EA-07-047

Response to Open Issues from HCV-345 Regulatory Conference

Additional Fire Perspectives for HCV-345 Containment Spray Valve
{Provided by OPPD}

Subject: **HRA Review Comments and Recommendations on OPPD HCV-345 Mispositioning SDP, Revision 1**

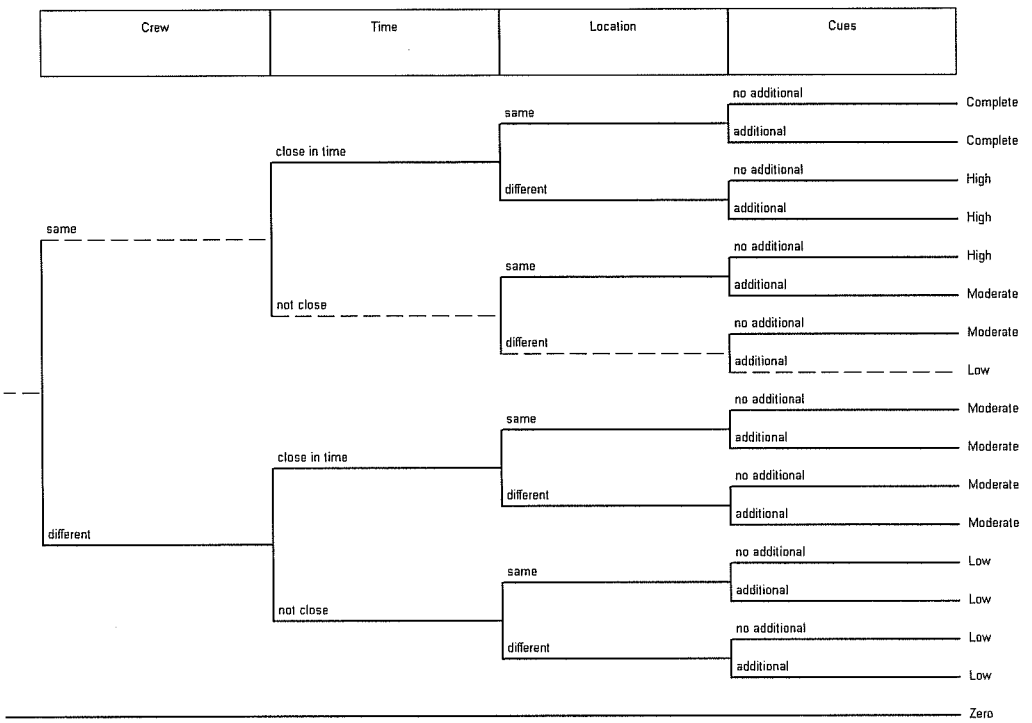
Factor	Determination
Crew	Same crew as the probability of a shift change for 12 hour shifts during the 90 minute time window is small (0.125)
Time	Not close in time as the time available for recovery is 88 minutes and each action, which takes less than a minute each, can be performed more than an hour apart. Even though the initial responses may be a few minutes apart, time is not a restrictive driving factor as there is sufficient time for multiple recoveries.
Location	Different location as the controls for HPSI are on the A33-1, A33-2, A34-1 and A34-2 panels, while the HCV-347 and HCV-348 controls are on the CB1, 2, 3 panels on different sides in the control room.
Cues	Additional cues that can be credited are the Reactor Vessel Level Monitoring System (RVLMS) indications, which are monitored by the STA as part of the safety function monitoring every 10 minutes. So, should the operators initially fail to diagnose LOCA based upon lowering of pressurizer level, RCS pressure and subcooling, the LOCA will manifest due to lowering of reactor vessel level. The STA also reviews SI flow requirements per Attachment 3 as part of the safety function monitoring, which can be credited as a cue for recovery of HPSI.

Given the dependency factors above, the SPAR-H dependency decision tree evaluates to "Low" as show below:

Given the "Low" level of dependence, the conditional HEP evaluates to 0.05, based on the THERP dependency formulas used in SPAR-H.

6.4 XSPRAYVALVE, Operator fails to respond to open CS valve

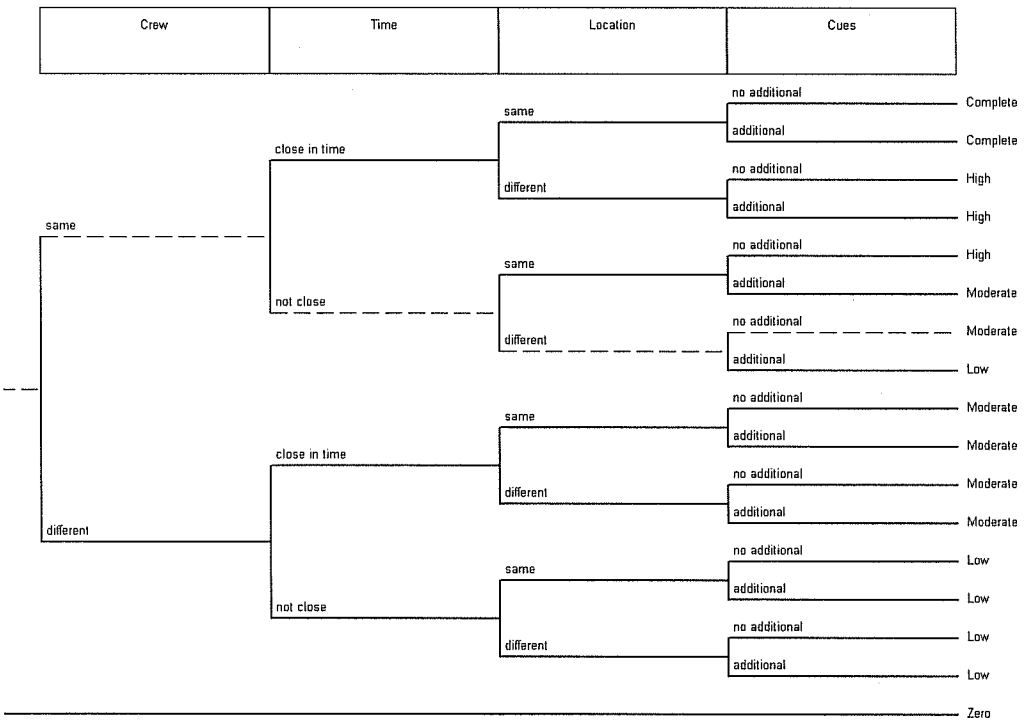
Factor	Determination
Crew	Same crew as the probability of a shift change for 12 hour shifts during the 90 minute time window is small (0.125)
Time	Not close in time as the time available for recovery is 88 minutes and each action, which takes less than a minute each, can be performed more than an hour apart. Even though the initial responses may be a few minutes apart, time is not a restrictive driving factor as there is sufficient time for multiple recoveries.

Factor	Determination
Location	Different location, as the controls for HPSI are on the A33-1, A33-2, A34-1 and A34-2 panels, while the HCV-347 and HCV-348 controls are on the CB1, 2, 3 panels on different sides in the control room.
Cues	No additional cues are credited.

Given the dependency factors above, the SPAR-H dependency decision tree evaluates to "Moderate" as show below:

Given the "Moderate" level of dependence, the conditional HEP evaluates to 0.14, based on the THERP dependency formulas used in SPAR-H.
